ST. CHARLES
CATHOLIC CHURCH | CLARENDON

**ST. CHARLES BORROMEIO
CATHOLIC CHURCH**
CLARENDON SECTOR PLAN
PROPOSED CHANGES

November 18, 2020

MAP 2.7: MAXIMUM HEIGHT LIMITS

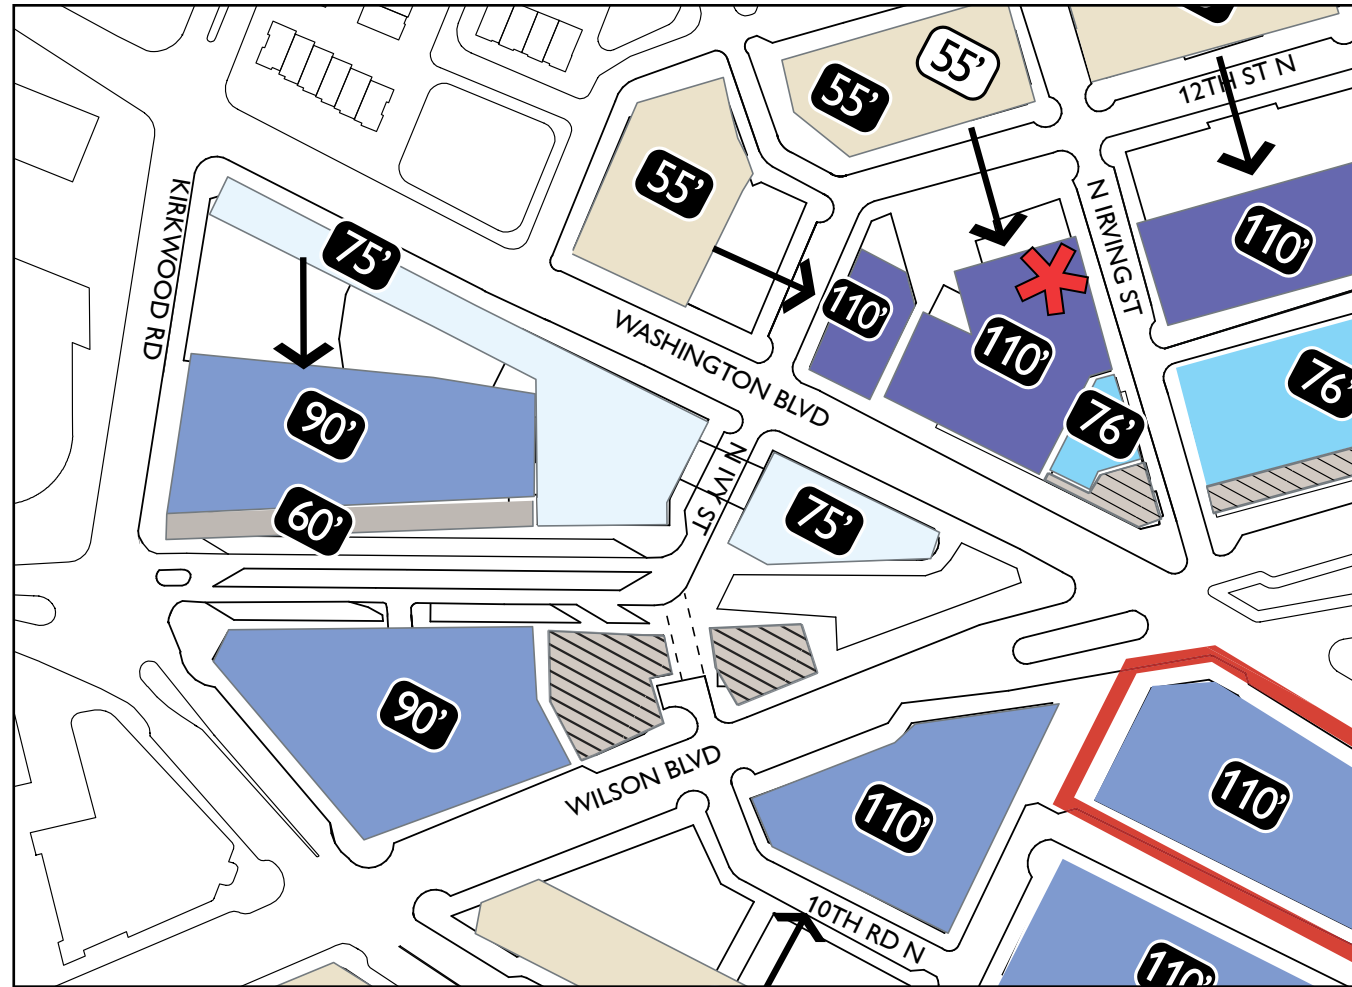
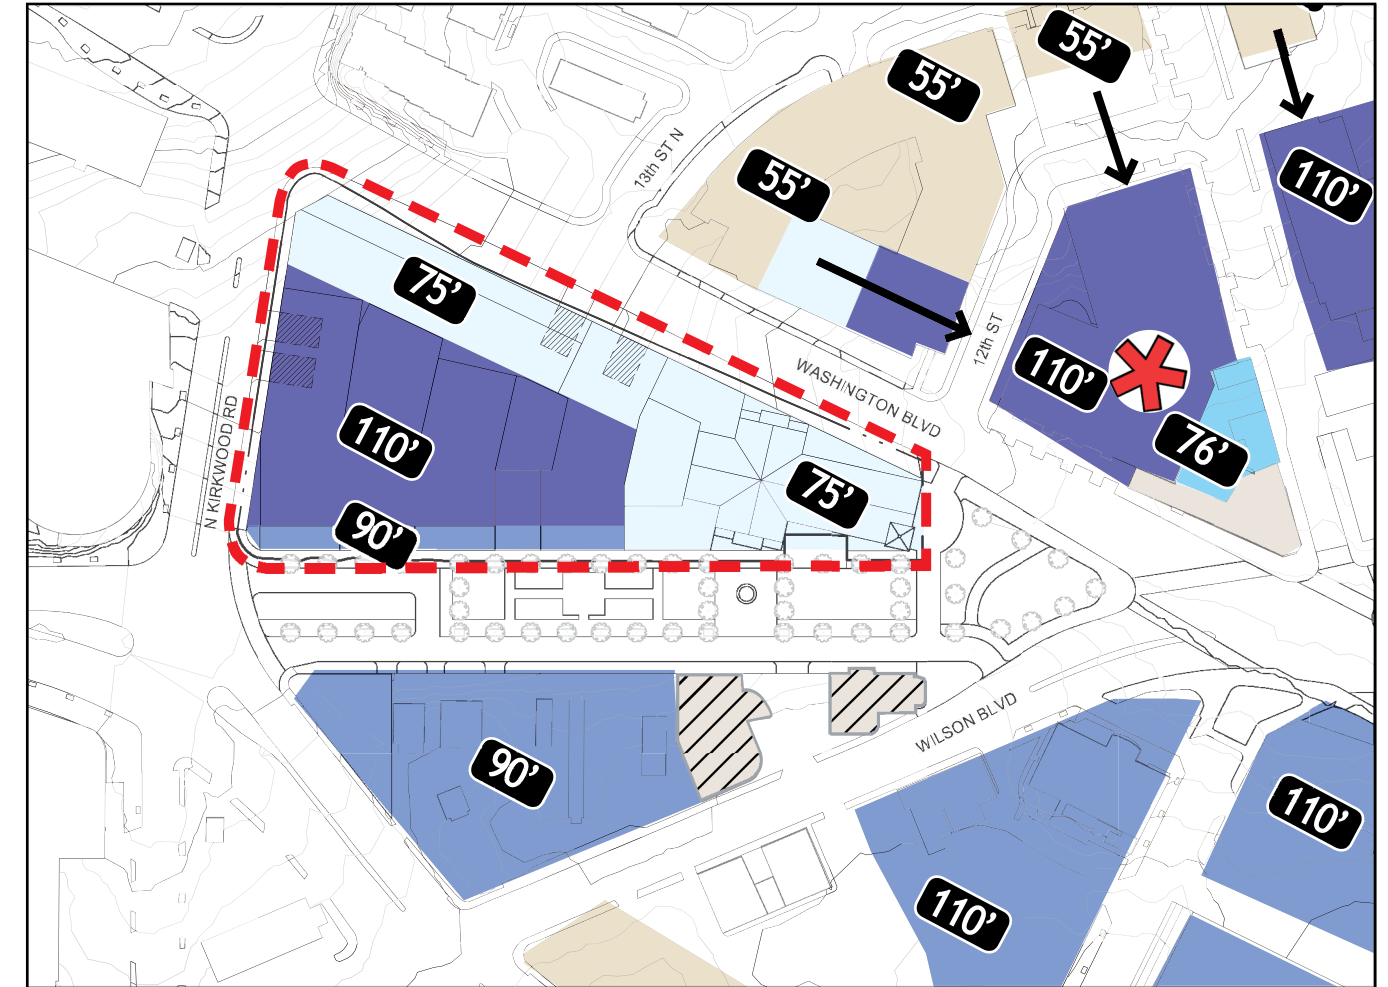
- Replace 1:3 Taper Requirement along Washington Blvd with a 65' step-back above 75'.
- Increase maximum height in the center of the site to 110'.
- Revise 60' height limit along Fairfax Drive to 90' to match 90' limit on south side of Fairfax Drive. Include a 20' step-back above 90' along Fairfax Drive.

PROPOSED CHANGES TO SECTOR PLAN REQUIREMENTS

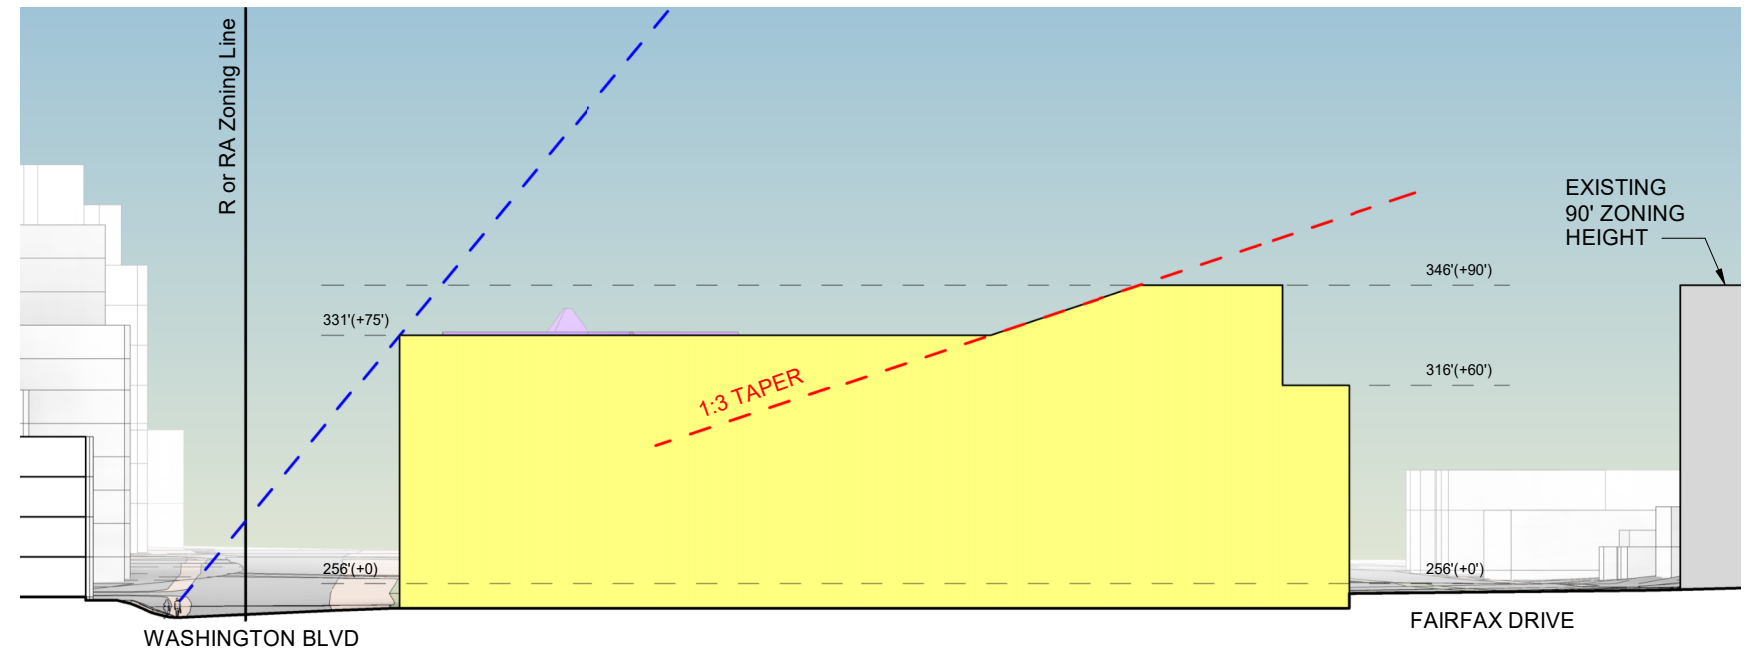
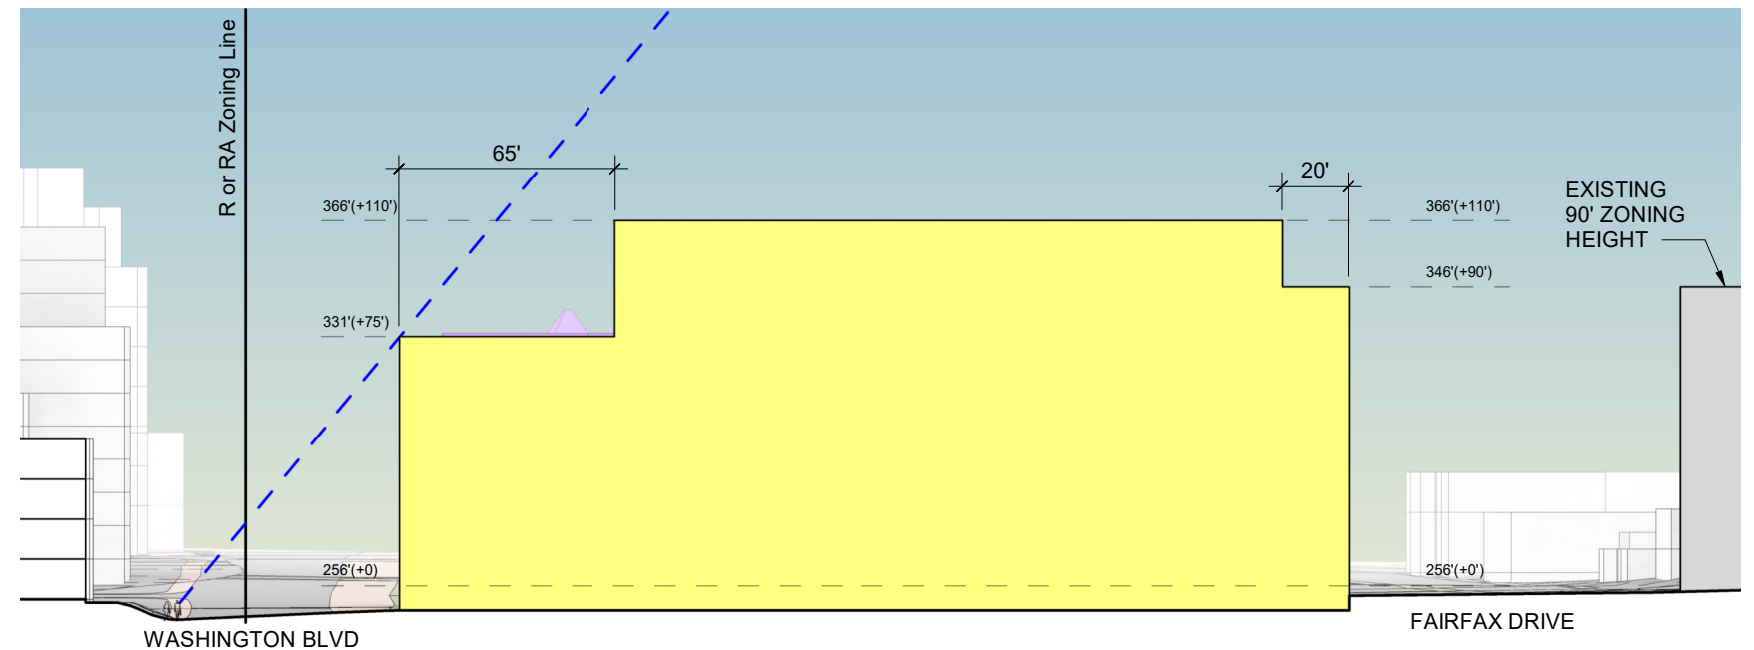
- Replace 1:3 Taper Requirement along Washington Blvd with a 65' step-back above 75'. A 65' step-back maintains appropriate transition to residential neighborhoods and does not negatively impact pedestrian sight lines. This also allows for a more practical building envelope.
- Increase maximum height in the center of the site to 110'. This proposed change allows for a more practical building envelope that is consistent with its surroundings and respectful of sight lines.
- Revise 60' height limit along Fairfax Drive to 90' to match 90' limit on south side of Fairfax Drive. Include a 20' step-back above 90' along Fairfax Drive. This allows for consistency with neighboring guidelines.

MAP 2.5: USE MIX

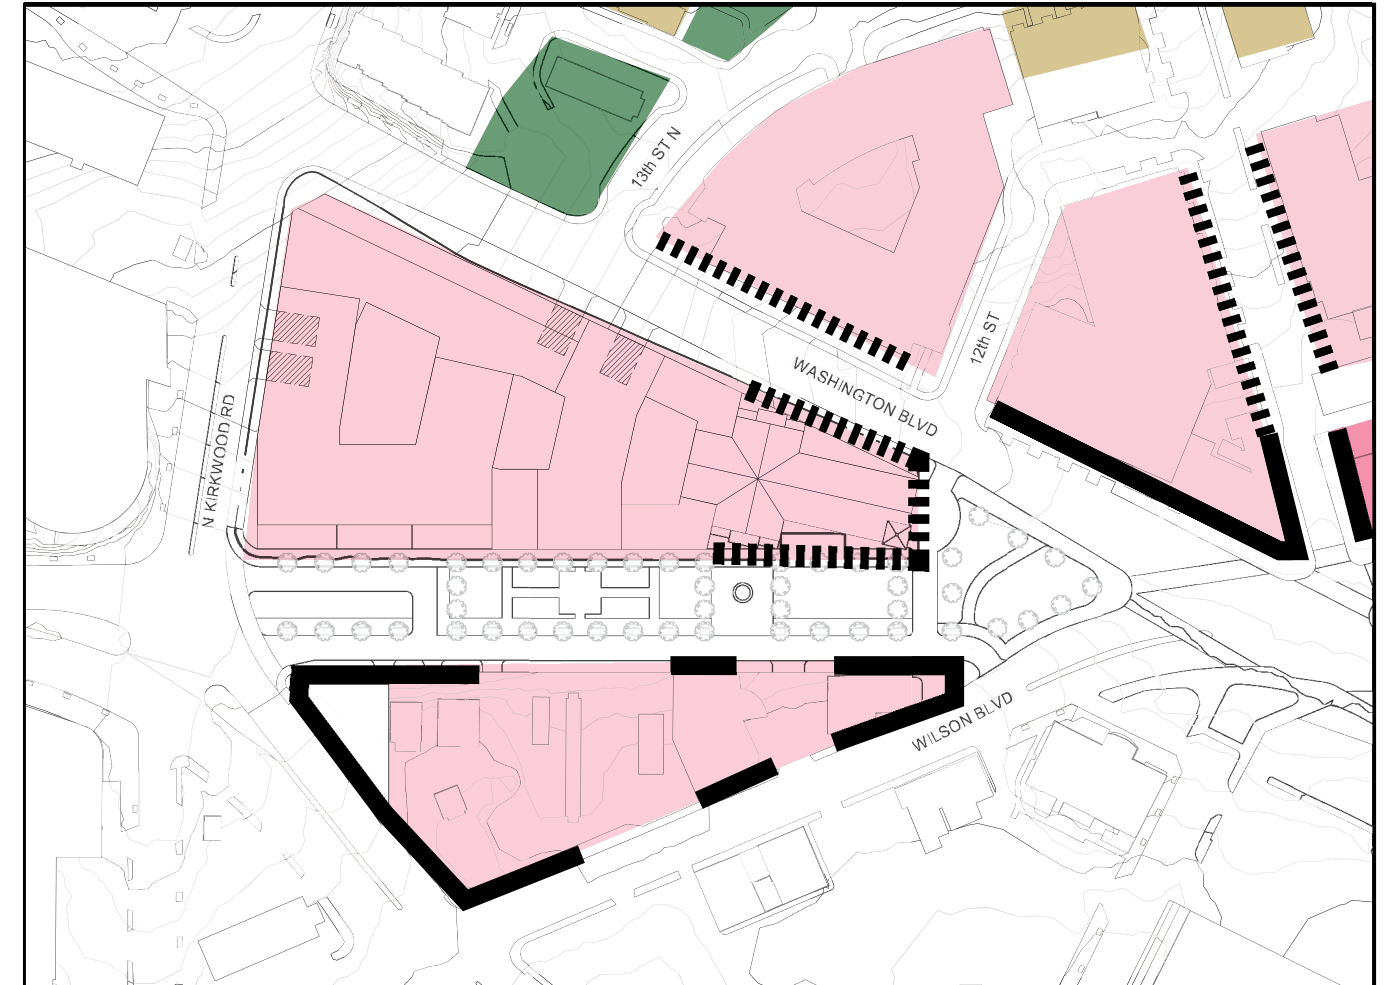
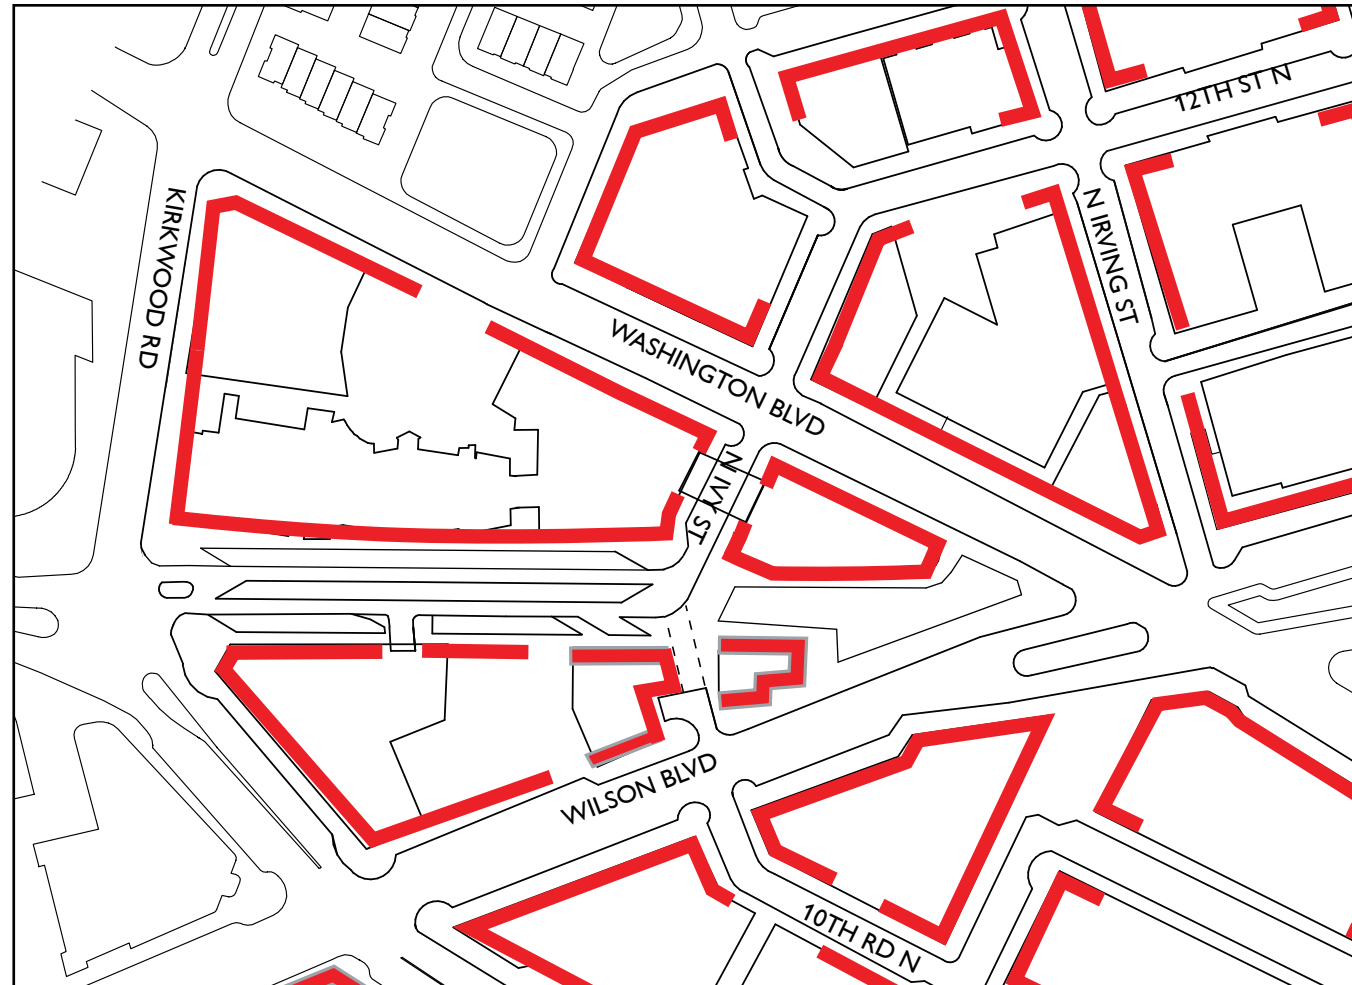
- Change “Retail Frontages” on east end of the site to “Retail and/or Personal/Business Service Frontages”
- Omit “Retail and/or Personal/Business Service Frontages” along Washington Blvd and N. Kirkwood.

Amending these guidelines better reflects the realities of retail along Washington Blvd, the site's envisioned needs, and the potential conversion of Fairfax Drive into the primary pedestrian connection to Virginia Square.

MAP 3.1: BUILD-TO LINES

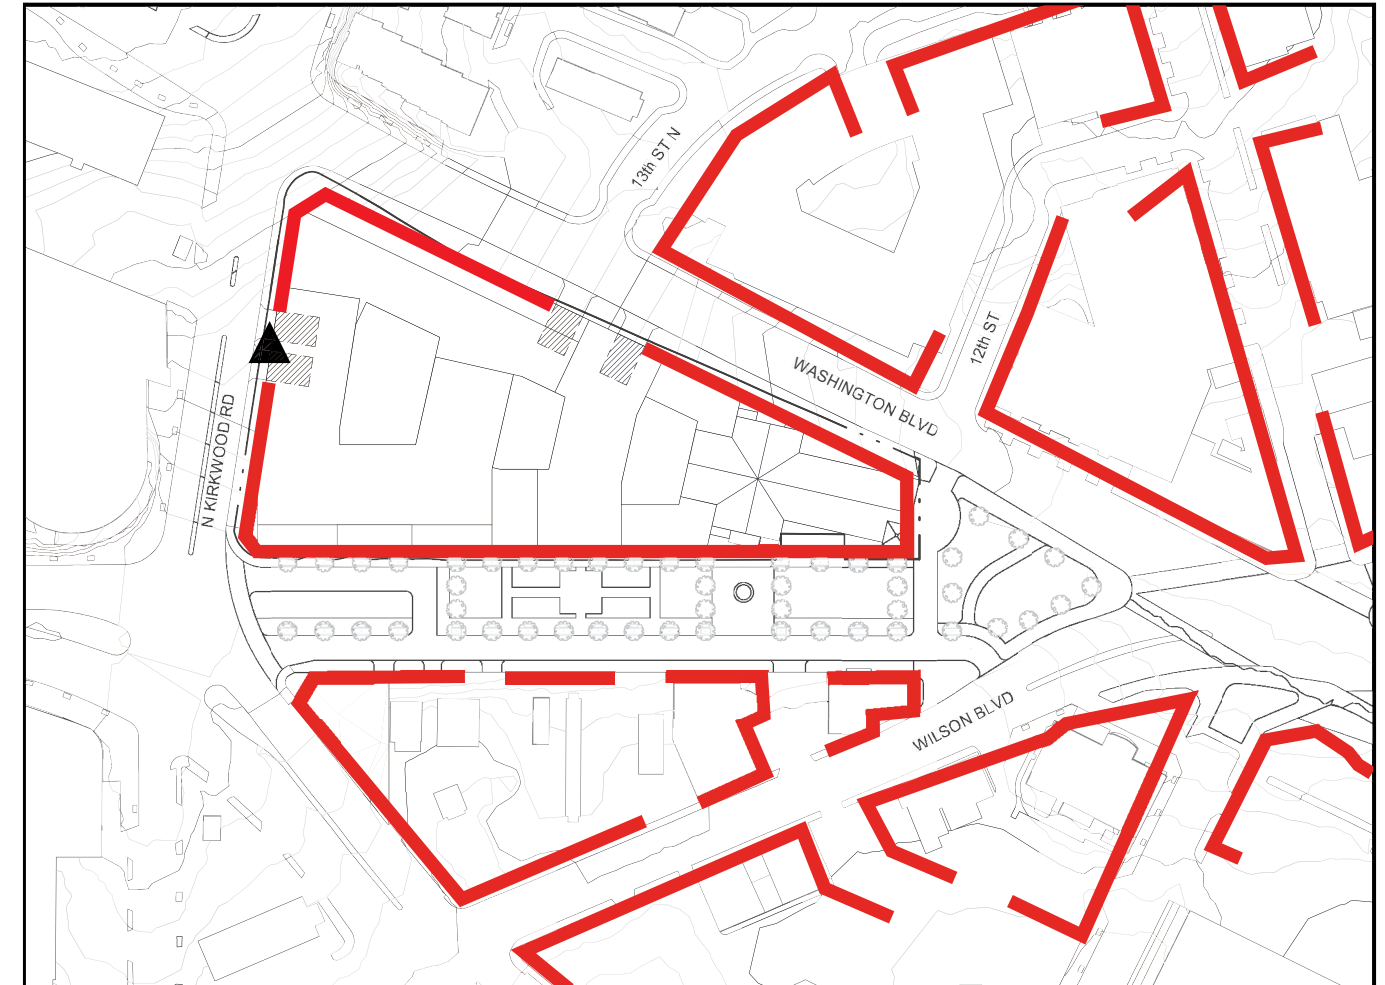
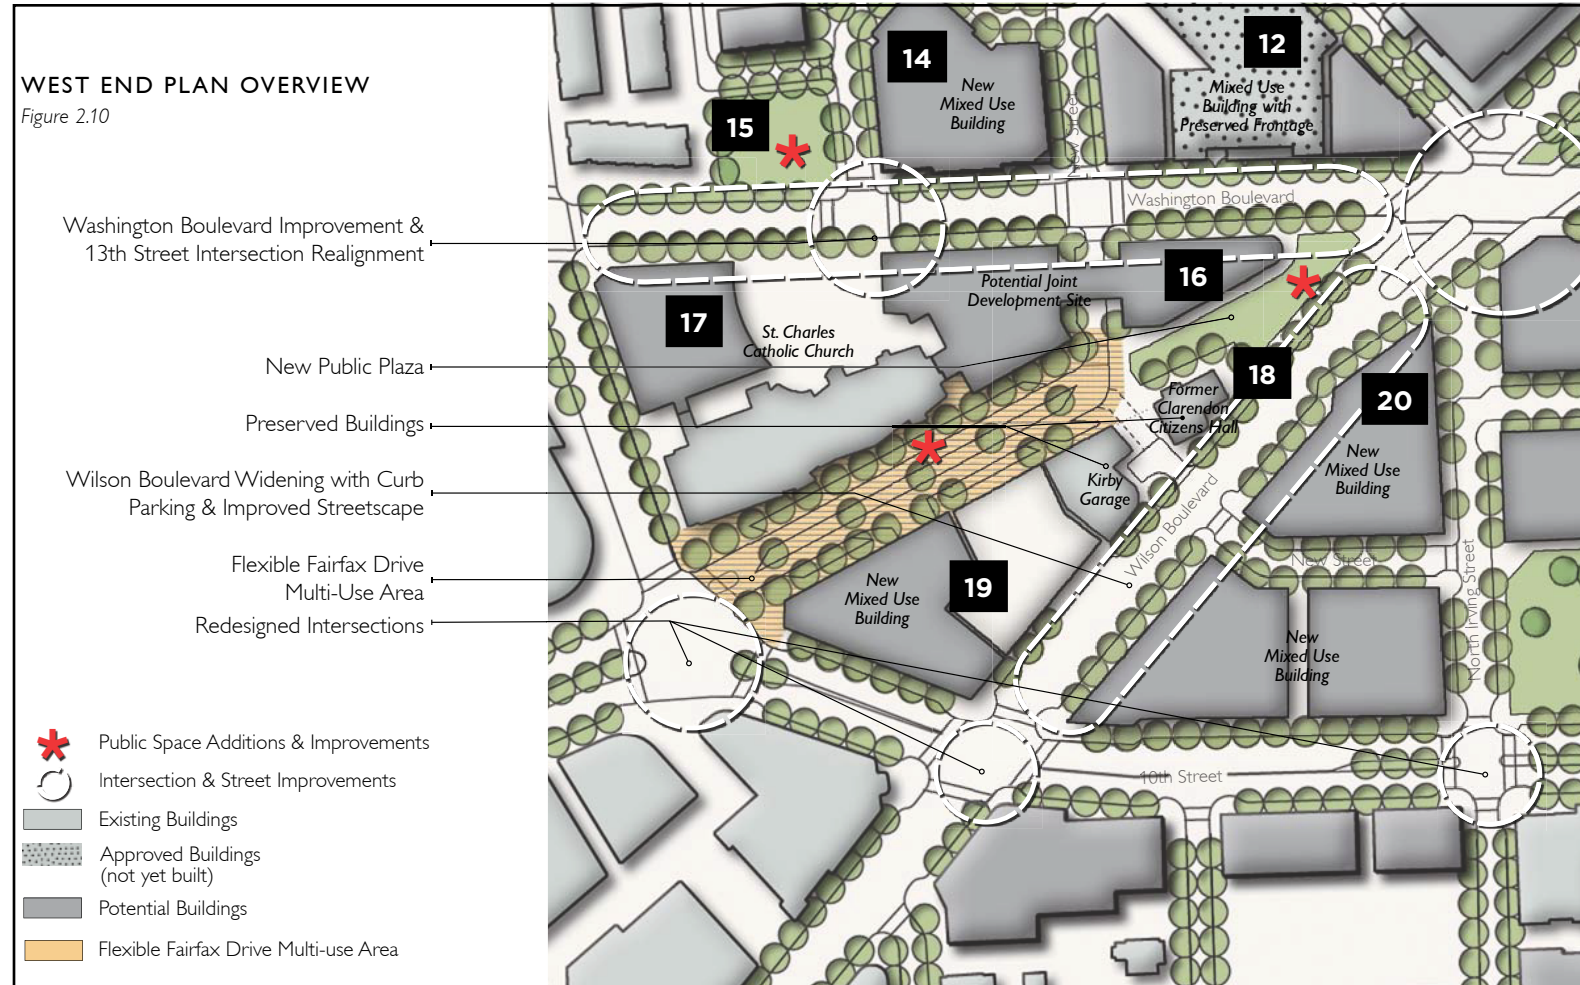
The current Sector Plan only allows for loading and parking access on Washington Blvd; this requirement is not sensitive to the unique, peak transportation requirements associated with religious services.

- Allow Parking and Loading access on Kirkwood in addition to Washington Blvd. Grade and natural topography along Kirkwood Rd make it easier to accommodate the extra height required by a loading bay. There is also an existing curbcut in the median for the GMU loading access.

Additional parking and loading access on Kirkwood works with existing site topography, mirrors existing parking and loading access across the street, and alleviates traffic along Washington Blvd.
